Interactive comment on “Does temperature affect the accuracy of vented pressure transducer in fine-scale water level measurement?” by Z. Liu and C. W. Higgins

Z. Liu and C. W. Higgins

1. Reviewer's comment

Fig. 1. A schematic of the field monitoring site.

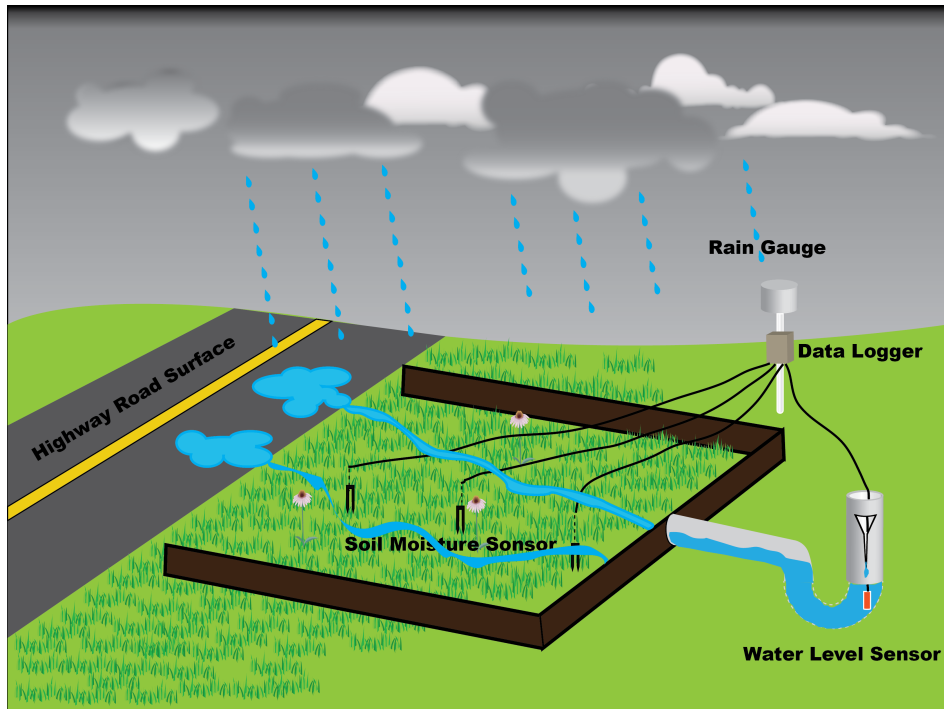
(5) page 5, 2.2, 17, Where is located the EM50 datalogger?

Response: The datalogger was installed within few meters from where the CTD sensor is installed. We also installed soil moisture sensors and a rain gauge for the monitoring site so the datalogger was placed where all the sensors can reach. The exact location differs for different sites. Figure.1 shows a general idea about how the datalogger is placed.

Fig. 2. A revised Figure 2.

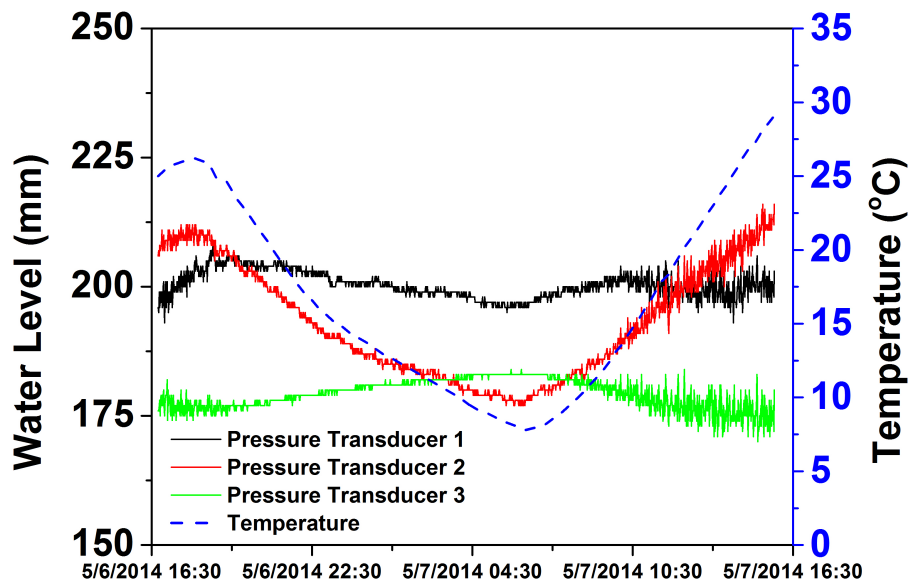
(8) page 21 - Figure 2 and page 25 - Figure 6, The scale of water level vertical axis of the graph would be better 150-250.

Response: We modified figure 2 and figure 6 as the reviewer suggested. Please see Figure.2 and Figure.3 in this file.
